Access Compliance Report Public Rights-of-Way (Curb Ramps)

Main Street: CERRERO_CT Cross Street: SALIENTE_RD Location: NE

ADA ID: RPAT211104095649 Ramp Type: Type 4 - Parallel Initial Pass/Fail: Fail Overall Compliance: No Severity Score: 2

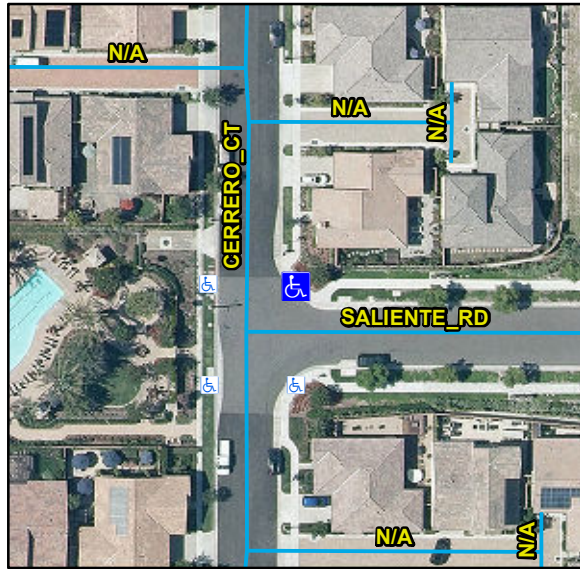
Compliance	Description	Data	Compliance	Description	Data
N/A	Ramp Length LT (in)	106	N/A	Ramp Length RT (in)	98
Yes	Ramp Width LT (in)	55	Yes	Ramp Width RT (in)	54
Yes	Ramp Run Slope LT (%)	7.2	Yes	Ramp Run Slope RT (%)	5.7
Yes	Ramp Cross Slope LT (%)	1.5	No	Ramp Cross Slope RT (%)	2.3
N/A	Landing Present	N/A	N/A	DWS Provided	N/A
N/A	Landing Length (in)	N/A	N/A	DWS Contrast	N/A
N/A	Landing Width (in)	N/A	N/A	DWS Length (in)	N/A
N/A	Landing Run Slope (%)	N/A	N/A	DWS Full Width	N/A
N/A	Landing Cross Slope (%)	N/A		DWS Offset Type	N/A
N/A	Landing Movement Obstructed?	N/A	N/A	DWS Offset Left (in)	N/A
	Landing Movement Type	N/A	N/A	DWS Offset Right (in)	N/A
N/A	Landing Shared	N/A			
N/A	Clear Space	Yes			
N/A	Clear Space To Crosswalk (in)	N/A			
N/A	Marked Crosswalk 1	No	N/A	Marked Crosswalk 2	No
	Crossing 1 Direction	W		Crossing 2 Direction	S
	Marked Crosswalk 1 Width (in)	N/A		Marked Crosswalk 2 Width (in)	N/A

Remove & Replace Curb Ramp With Two New Directional Ramps or Equivalent.

R304.5.3, STD 1115
